Proposal #40: 1050-00-60, WISC 2026157
Chippewa Falls - Abbotsford
320TH Street to Koser Ave EB & WB
STH 29
Chippewa and Clark Counties

This is Addendum No. 01, which provides for the following:

ADDENDUM NO. 01
PROJECT ID 1050-00-60
January 8, 2026

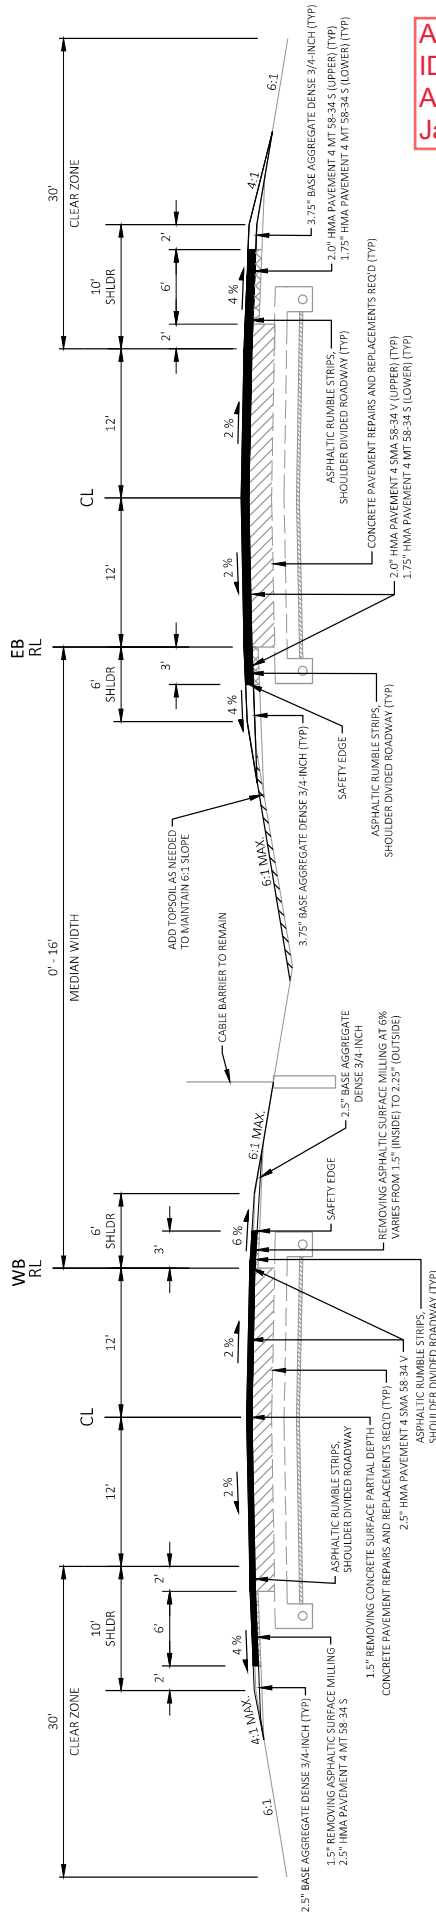
Revised Plan Sheets	
Plan Sheet	Plan Sheet Title (brief description of changes to sheet)
4	Typical Sections (added existing cable barrier and stationing)
9	Typical Sections (revise stationing to remove cable barrier limits)
21	Construction Details (add construction detail for reconstruction inlets)
27	Intersection Details (revised curb elevation)
44	Miscellaneous Quantities (added Removing Concrete Surface Partial Depth and revised milling quantity)
46	Miscellaneous Quantities (revised tack coat, HMA pavement, and base aggregate quantities near cable barrier)
47	Miscellaneous Quantities (revised HMA PWL mixture use table)
50	Miscellaneous Quantities (added Inlet Protection Type A)
51	Miscellaneous Quantities (revised restoration quantities near cable barrier)

STA 990'WB+00 - 1051'WB+62	STA 990'EB+00 - 1051'EB+62
STA 1073'WB+62 - 1076'WB+85	STA 1073'EB+80 - 1076'EB+85
STA 1144'WB+13 - 1167'WB+56	STA 1144'EB+13 - 1167'EB+53
STA 1168'WB+99 - 1364'WB+44	STA 1168'EB+96 - 1364'EB+44

SHEET 9A

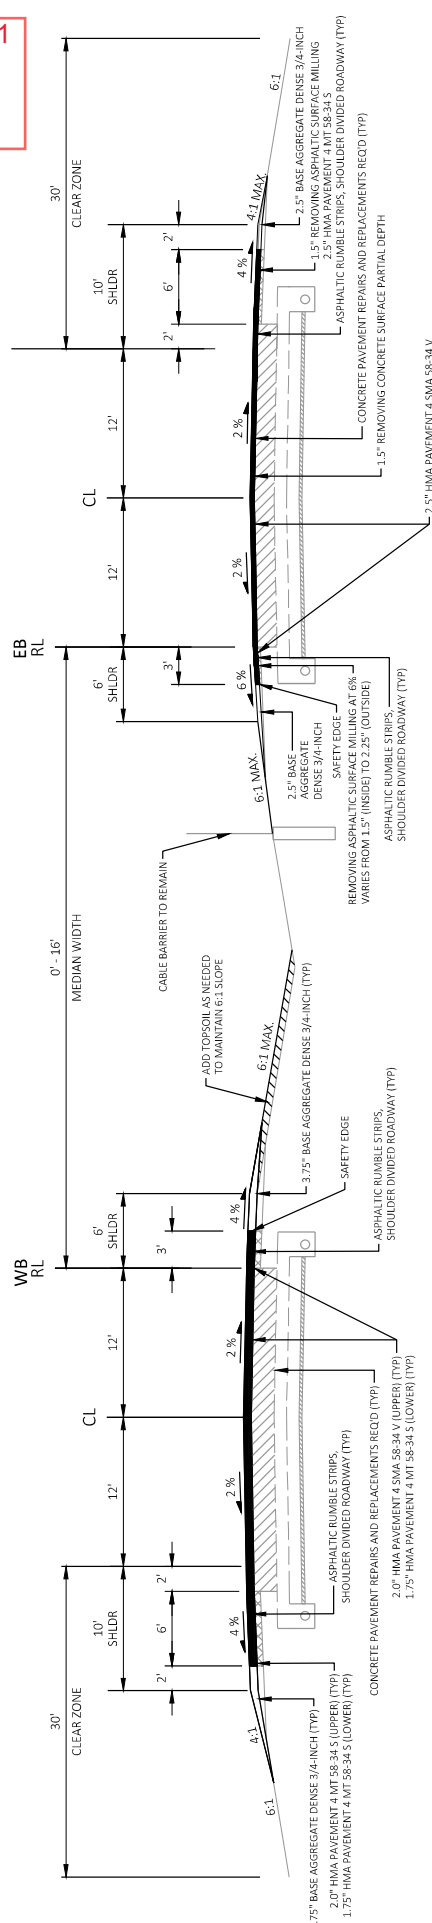
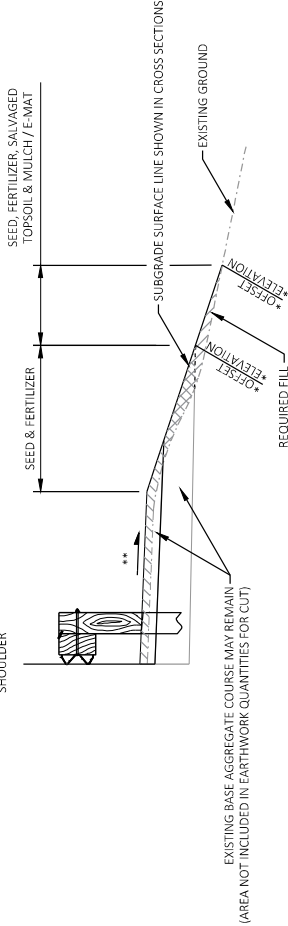
Added Plan Sheets	
Plan Sheet	Plan Sheet Title (brief description of why sheet was added)
3A	Project Overview – Cable Barrier (show cable barrier installed in 2025)
9A	Typical Sections (add revised sections for areas near cable barrier)
47A	Miscellaneous Quantities (expanded HMA PWL mixture use table and added Reconstruction Inlets table)
73A	SDD (added Inlets Median 1 and 2 Grate to plan)

FINISHED TYPICAL SECTION - STH 29

STA 1076WB+85 - 1144WB+13 STA 1076EB+85 - 1144EB+13

RECONSTRUCTION INLETS - MEDIAN

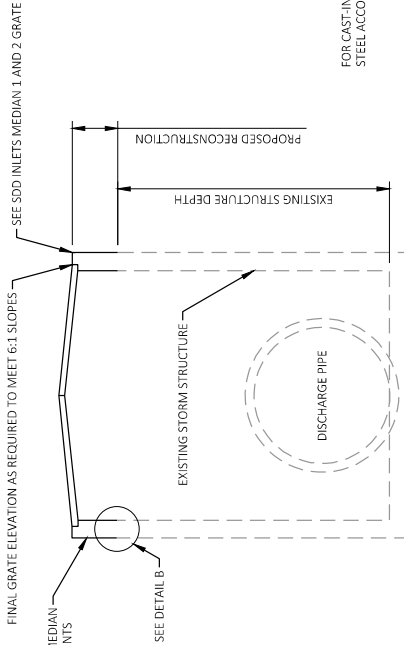
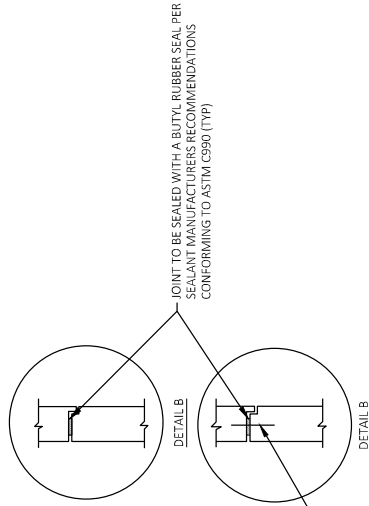
RECONSTRUCT INLET ON TOP OF EXISTING MEDIAN INLET TO MEET CONSTRUCTION REQUIREMENTS

- NOTES:
THE INLET RECONSTRUCTION SHALL BE CAST-IN-PLACE OR PRECAST TO MEET THE CONSTRUCTION REQUIREMENTS.
CONTRACTOR TO PROVIDE DRAWING(S) STAMPED BY A PROFESSIONAL ENGINEER FOR STEEL REINFORCING DESIGN FOR CAST-IN-PLACE STRUCTURES.
REFERENCE STANDARD DETAIL DRAWING INLETS MEDIAN 1 AND 2 GRATE FOR ADDITIONAL DETAILS, MATERIALS, AND DIMENSIONS.
